**Re: May Day Idaho Mine Complex, Sunrise Mining LLC, File No. M-1981-185, Rationale for Recommendation to Approve a 112d-2 Amendment Application with Objections**

**Re: May Day Idaho Mine Complex, File No. M-1981-185, 112d-2 Amendment Application  
(AM-2) Request for Final Clarifications**

**Exhibit B;**  
**Storm Water Management Structure Map**  
**Figure C-7**

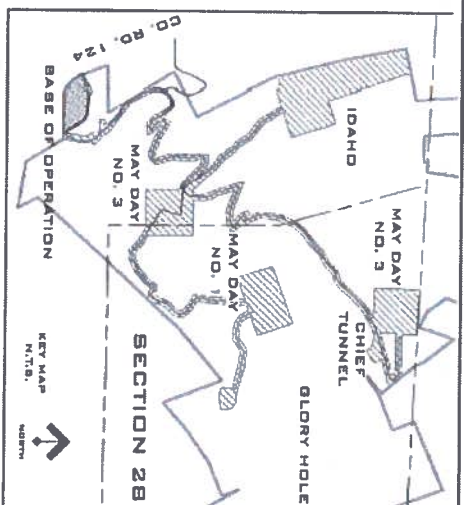
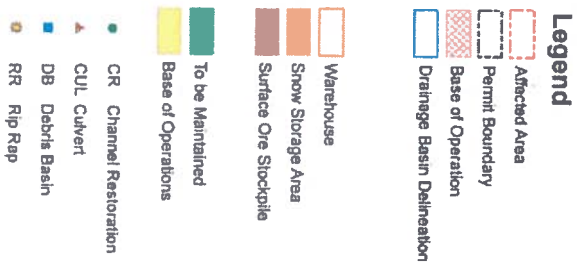
Pursuant to Rule 6.4.21 (10) - Surface Water Control and Containment Facilities Information; The Applicant must provide design specifications certified by a licensed professional engineer for all Environmental Protection Facilities for the protection of surface waters. A stormwater management plan was established that included several stormwater control structures that include, but are not limited to, debris basins, bar ditches and water bars. The stormwater management plan was submitted and reviewed by the Colorado Department of Public Health and Environment and a Storm Water Discharge Permit has been issued, Permit No. COR03H717. The stormwater management plan as well as the engineering and construction specifications of each individual structure can be found in Exhibit U, Attachment U-3 as well as Exhibit G, Figure G-2. The locations of the structures are identified in Figures C-7, D-9, U-1 and U-6. A copy of Figure C-7 is included as Attachment B to this document.

Fig C-8

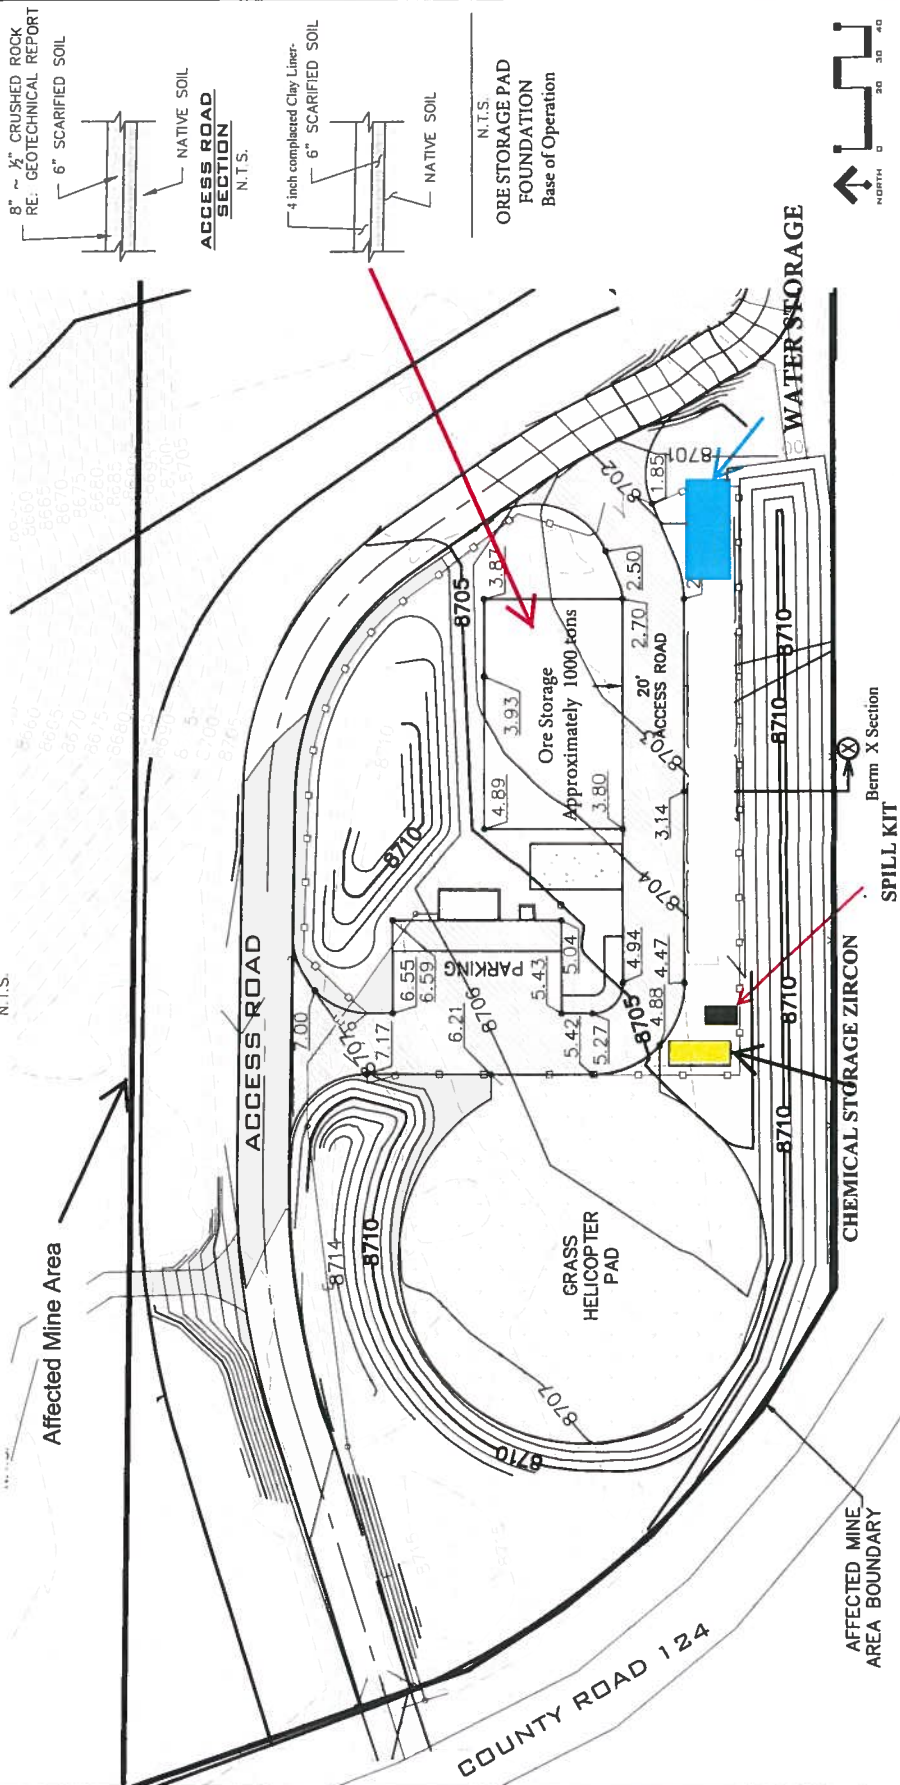
- a. In the previously submitted adequacy response dated November 9 2017, a narrative clarifying the construction details of the ore storage pad at the Base of Operations was included. Also included were amended figures C-8 and D-3. While that clarifies the construction details of the base of the ore pad, the secondary containment drawing was also removed from those figures. The Division wishes to clarify that in addition to the liner of the ore storage pad, it must also have secondary containment structures as detailed in the previously submitted figure D-3. Please commit to installing both the 4 inch compacted clay liner as well as the secondary containment berms around the perimeter of the ore storage pad as detailed in the upper left hand corner of the previously submitted figure D-3.

- b. Similarly in the updated figures C-8 and D-3 the fuel storage area with secondary containment has been removed from the plan for the Base of Operations. Please clarify that was the applicants intent, and that no fuel will be stored on site. If this was done in error, please submit a new Figure C-8 and D-3 that includes the

details of the fuel storage area with secondary containment as well as the details of secondary containment for the ore storage pad.

**Response: Secondary containment will be provided for the ore storage pad located at the base of operations. A 4-inch compacted clay liner will be installed on a six-inch scarified soil base as indicated and secondary containment berms will be built around the perimeter of the ore storage pad. The berms will be built to specifications approved by DRMS and details of the berms and the storage pad will be confirmed in as built drawings when the construction of the storage pad is complete.**

**Response: No fuel will be stored on site during the initial phases of operation. If fuel storage is necessary later, the requirement will be addressed through the Technical Revision Process.**
